Project			
Name:	Allison Way Apartments		
Address(es):	398 Stacy Allison Way & 3801 Hooper Street, Woodburn, OR 97071		
Tax Lot #(s):	052W14 02000, 02100 & 02300		
Applicant			
Name:	Eugene Labunsky	Title:	President
Phone:	503-989-1613	Firm:	West Coast Real Estate Holdings
Mailing Address:	25030 SW Parkway Ave, Suite 110; Wilsonville, OR 97070		
Email:	eugenel.wchs@gmail.com		
Applicant's Representative/Project Manager			
Name:	Doug Hamilton	Title:	Project Manager
Phone:	503-228-2840 ext 111	Firm:	Leeb Architects
Mailing Address:	308 SW 1st Ave, Suite 200; Portland, OR 97204		
Email:	dhamilton@leebarc.com		
Landowner			
Name:	Stacy Allison Way Holdings, LLC	Title:	
Phone:	503-989-1613	Firm:	West Coast Real Estate Holdings
Mailing Address:	25030 SW Parkway Ave, Suite 110; Wilsonville, OR 97070		
Email:	eugenel.wchs@gmail.com		
Architect			
Name:	see applicant's representative	Title:	
Phone:		Firm:	
Mailing Address:

Modification of Condition of Approval (EX2)

Written Narrative Detailing
"Existing" Stacy Allison Way - Street Improvements
Project area located adjacent to Phase 1 - Tax Lot 052W14-02300
Together with: "Extension" of Stacy Allison Way – Construction
Project area located

EXHIBIT E

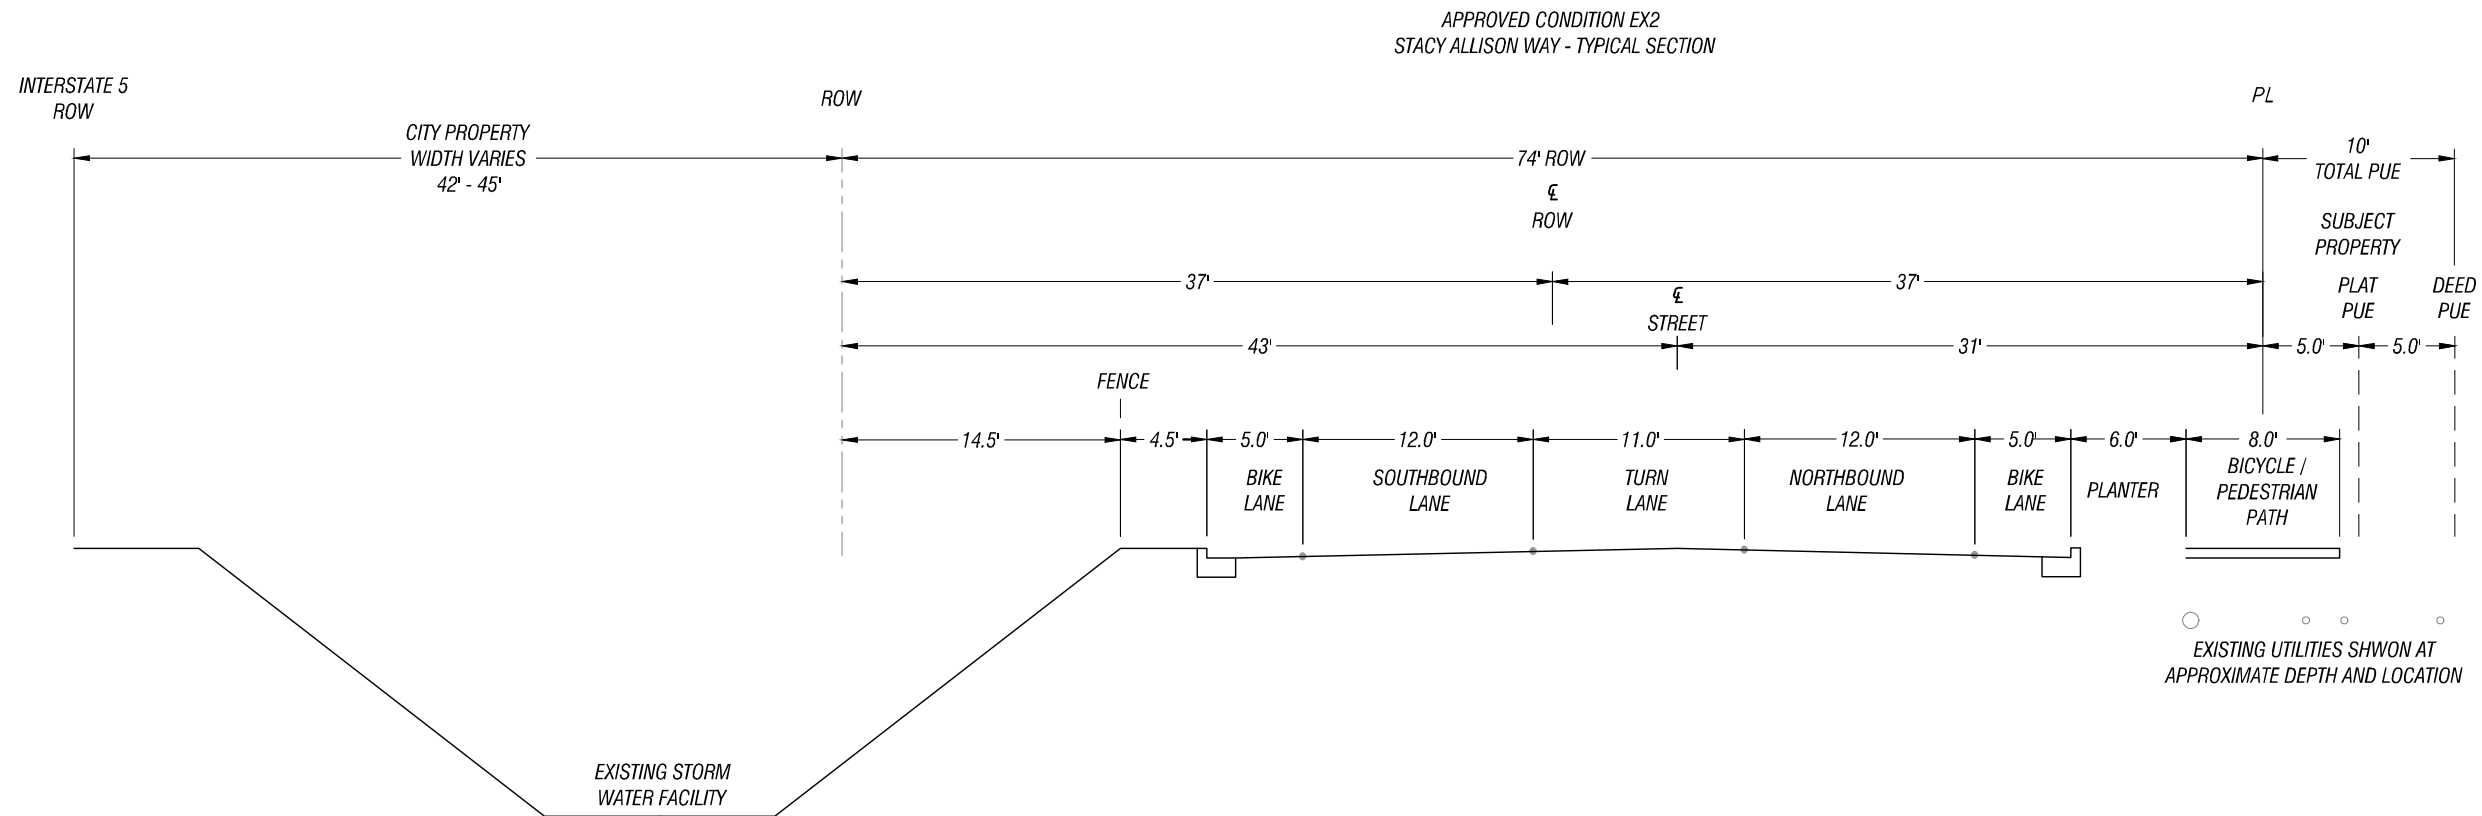
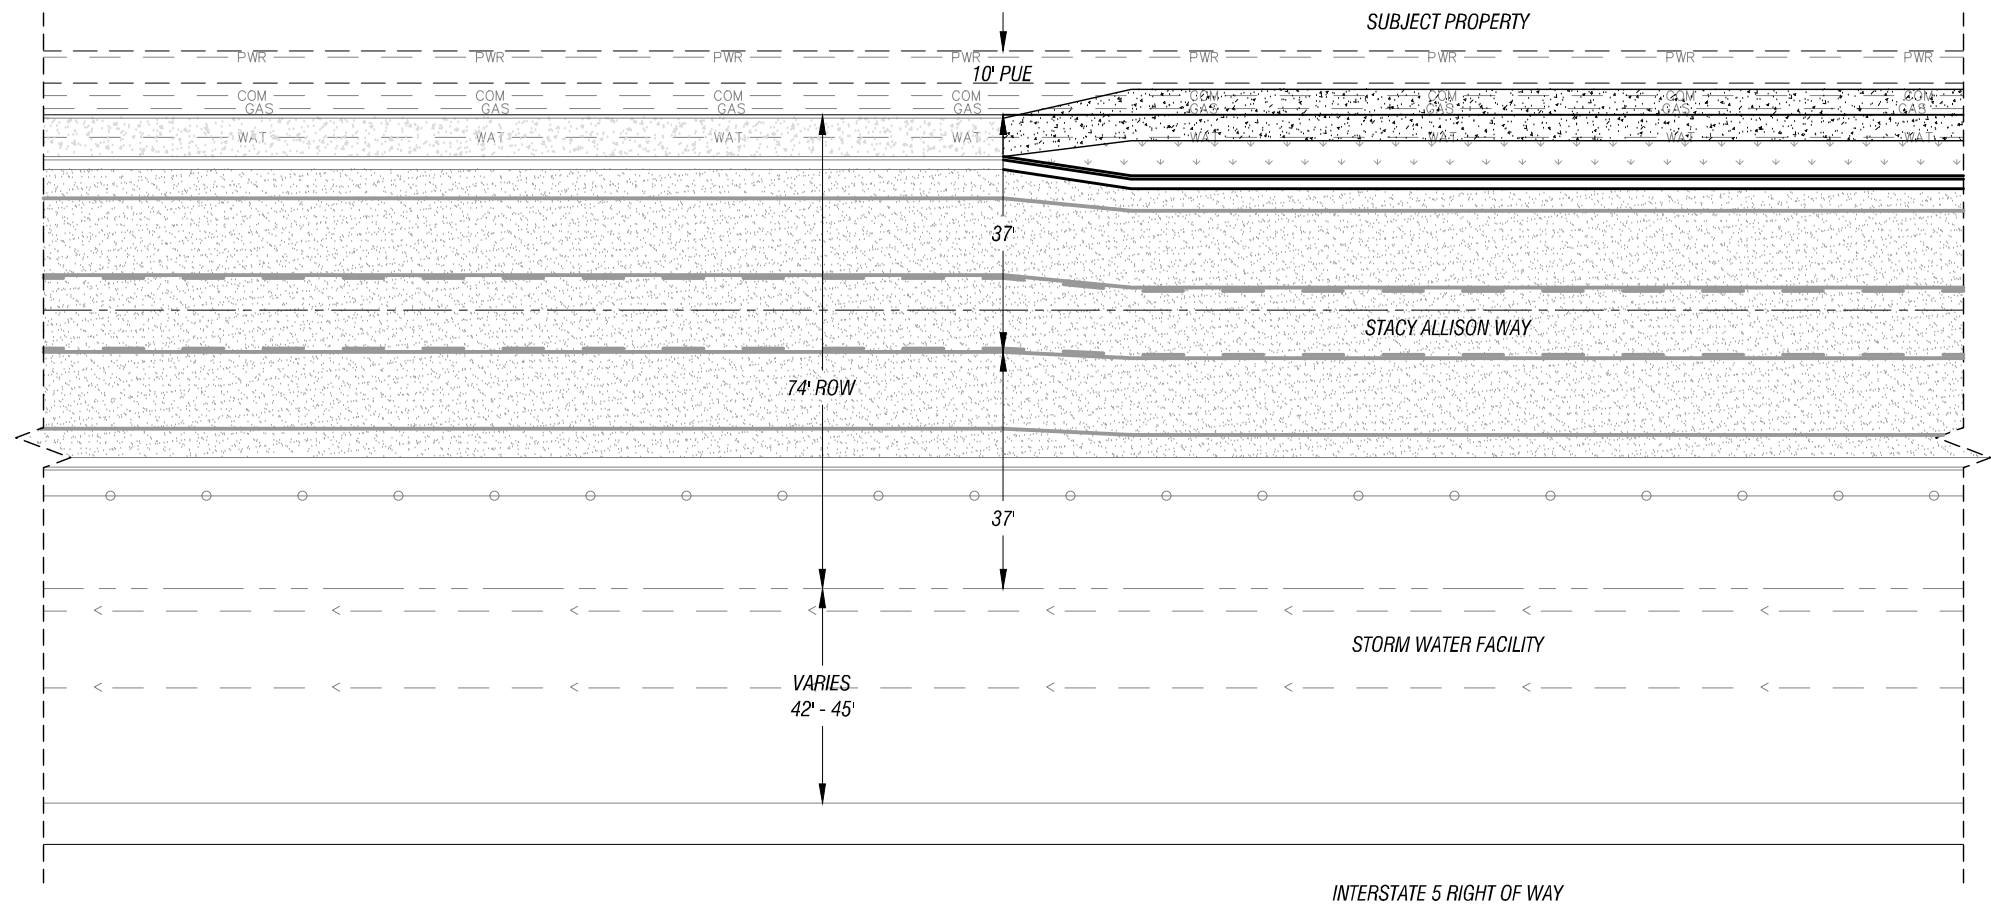
In summary, the approved condition EX2 calls for a shifting of the existing northbound curb alignment of 3' to the West. See Exhibit E – Approved Condition EX2 Stacy Allison Way Typical Section. This can be accomplished by narrowing of the southbound bike lane to minimum 5' width from existing 6' width, narrowing the center turn lane to minimum 11' width from existing 12' width and narrowing of the northbound bike lane to minimum 5' width from existing 6' width. This provides 3' width, the additional 3' needed to provide the requested 6' planter strip is created by removing the existing northbound sidewalk and shifting the front of walk (FOW) 3' east. Furthermore, the City has requested an 8' bicycle/pedestrian path northbound to be constructed of which 4.5' width would be onto our client's property i.e., overhang the ROW line onto the PUE by 4.5'.

This approved configuration would require Stacy Allison Way street to transition (shift) through the subject property deviating from its current straight standard alignment. In addition to the negative visual, bicycle traffic and vehicular traffic effects the approval comes at significant cost to the developer. The approval would require; removal of existing curb and gutter, removal of existing 6' northbound sidewalk, grinding/removal of existing striping, installation of new curb and gutter, installation of new northbound 8' bicycle/pedestrian path and restriping of Stacy Allison Way. This identifies the surface effects of the approval which alone is significant. In addition, there are also numerous underground utility conflicts. Most impactful is the City of Woodburn 10" waterline that currently is installed under the northbound sidewalk. The approval requires removal of the 10" waterline and then construction of a new replacement 10" waterline which likely will require it to be constructed within the asphalt street section along the southbound lane of Stacy Allison Way. This will require saw cutting and trench patching of the street at significant cost to the developer, create visual impacts and long-term maintenance of Stacy Allison Way.

EXHIBIT F

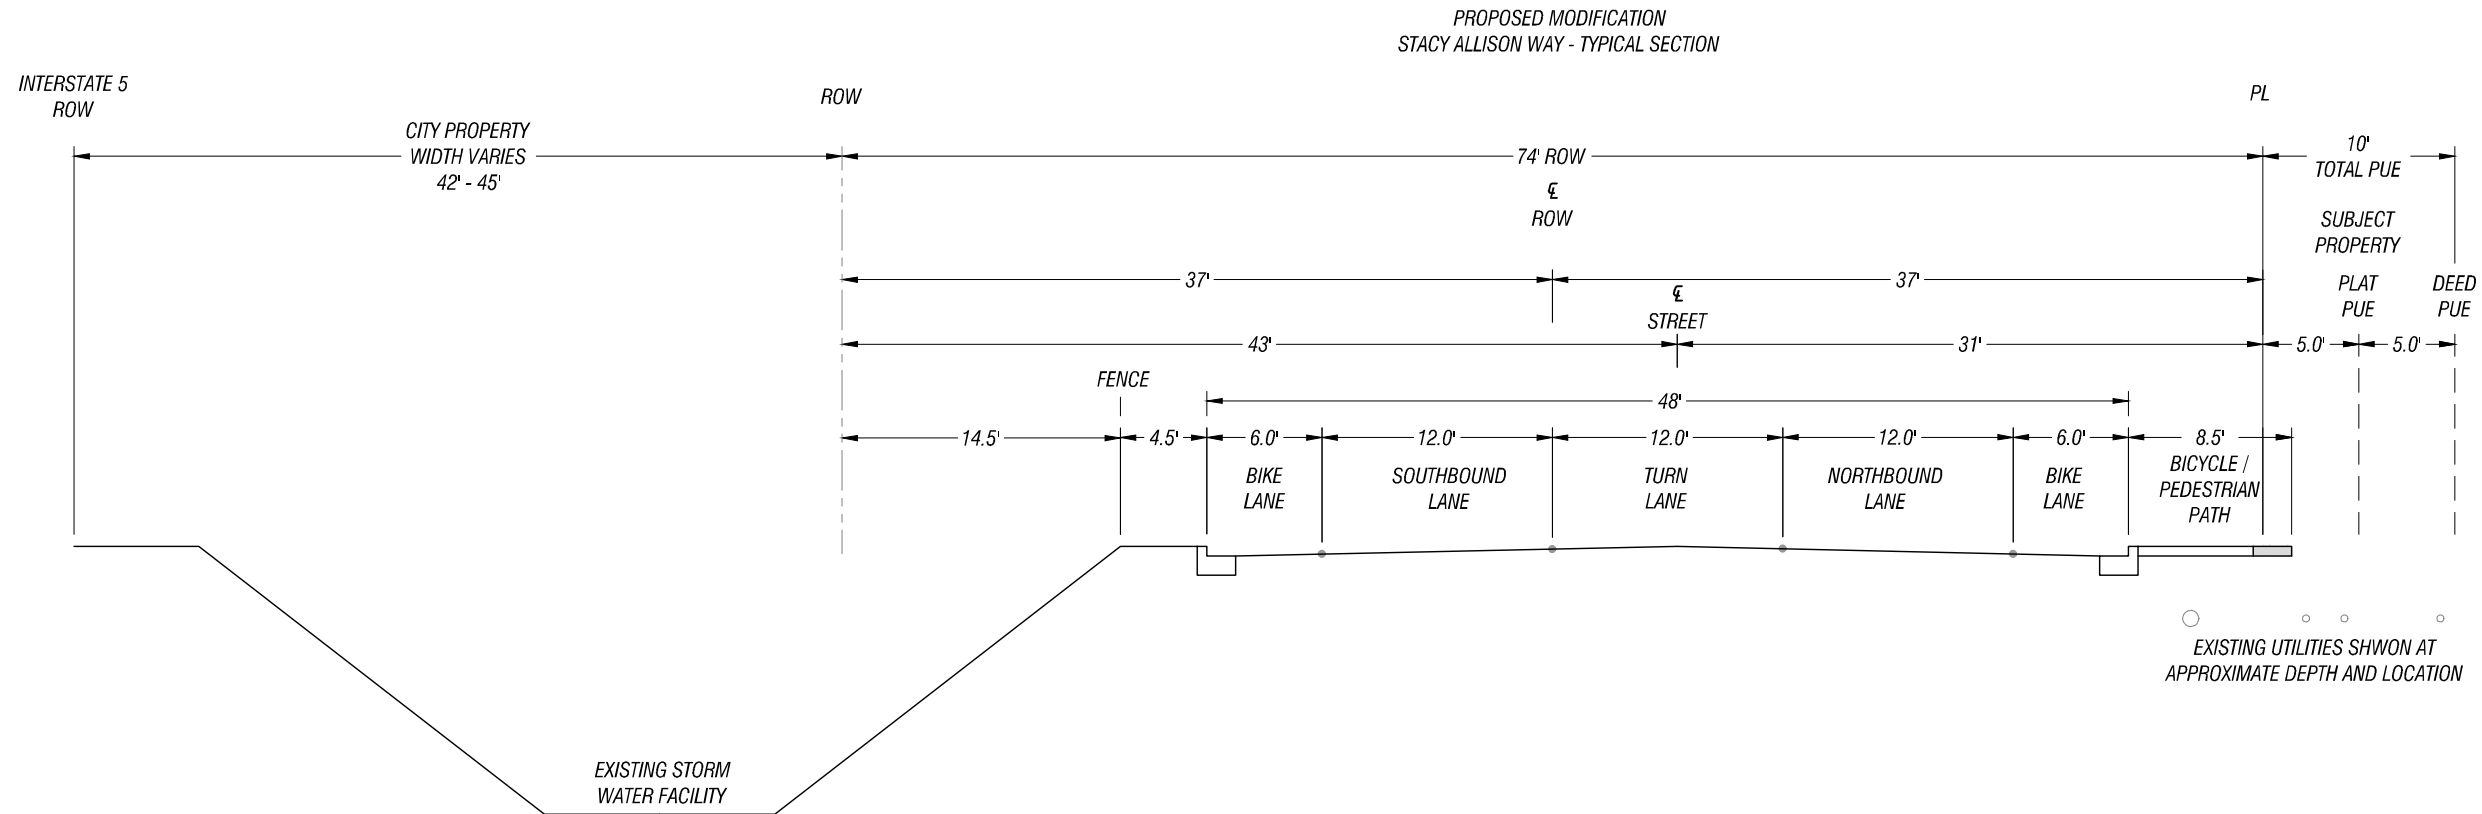
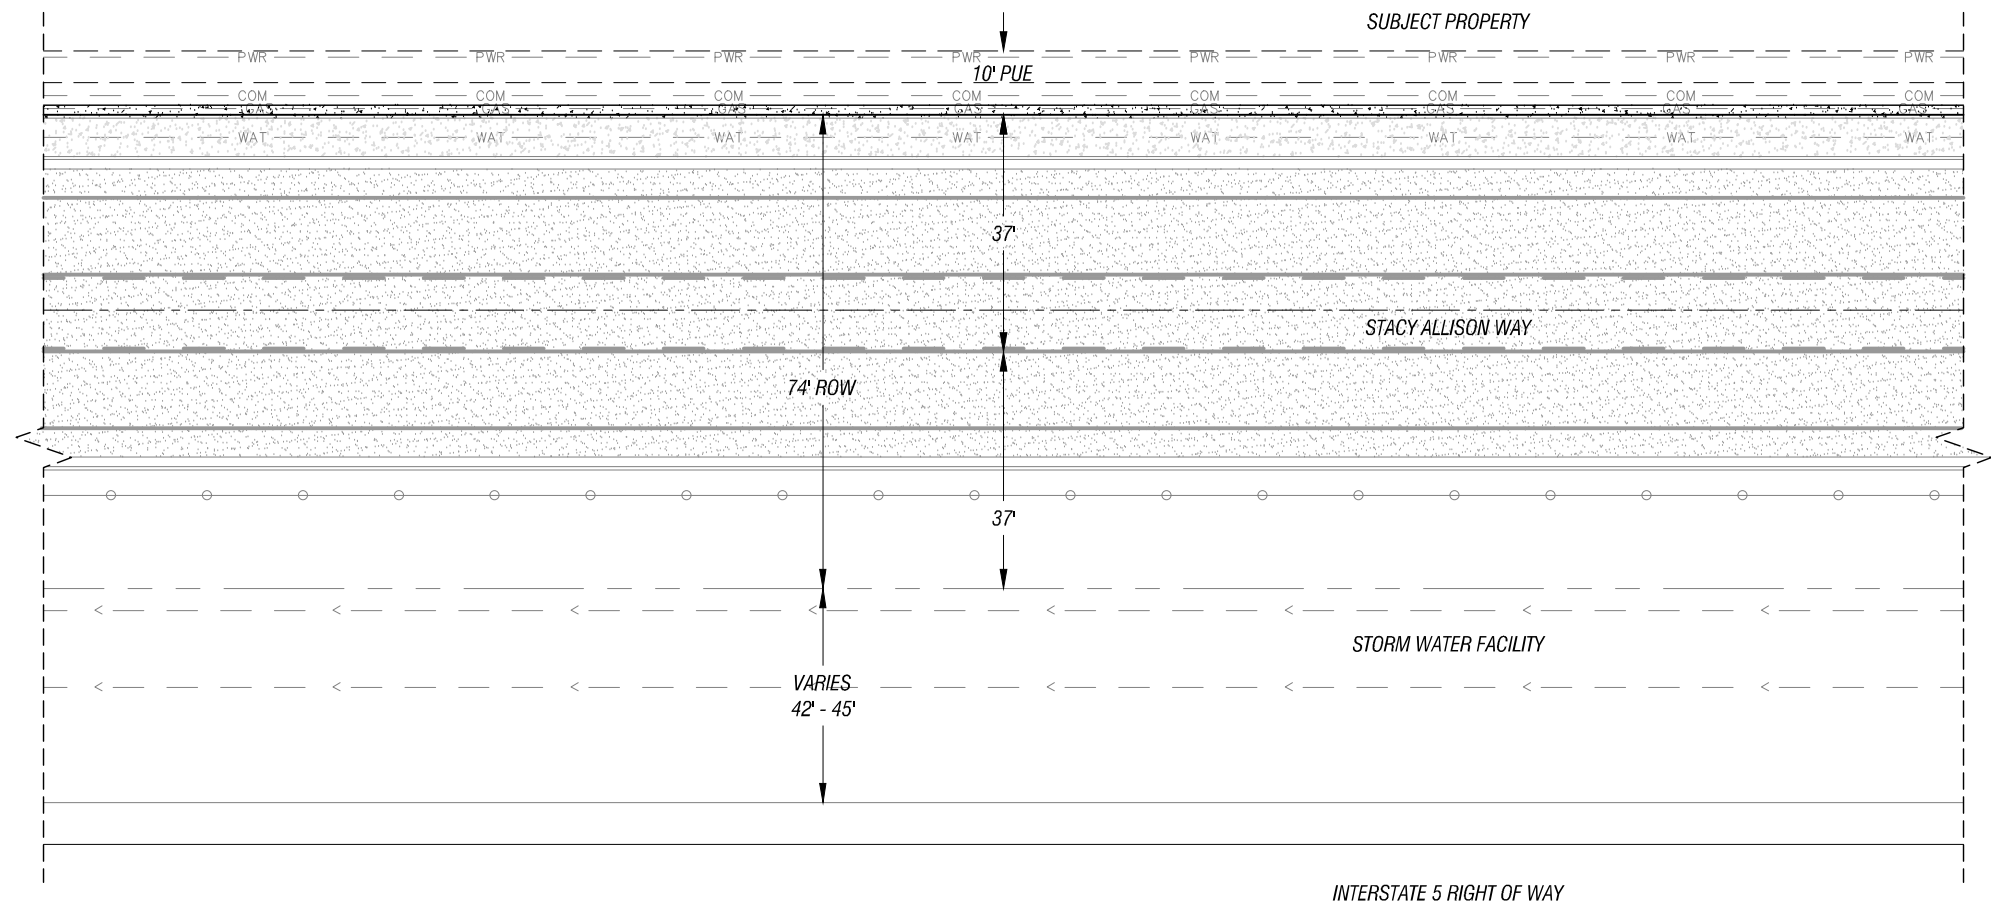
Our proposed modification considers the long standing well documented constraints that the City's storm water facility has created along the Stacy Allison Way corridor. This proposed modification also limits the impacts of said changes to the public for both bicycle & vehicle traffic safety, the City street & utilities infrastructure maintenance and the burden on the developer. See Exhibit F – Proposed Modification to Condition EX2 Stacy Allison Way Typical Section. This proposed section accommodates the current location of all existing City street improvements and City utilities while providing the approved 8' bicycle/pedestrian path.

In conclusion we are proposing this modification as a reasonable solution to the deviation from the standard to the current constructed street section for Stacy Alison Way. It is our belief that the combination of the; existing 6' width bike lane, existing 6" tall - 2' width curb & gutter and the requested 8' bicycle/pedestrian path provides separation for pedestrians from traffic as well as removes impacts to both bicycle & vehicle traffic safety and, the City street & utilities infrastructure.
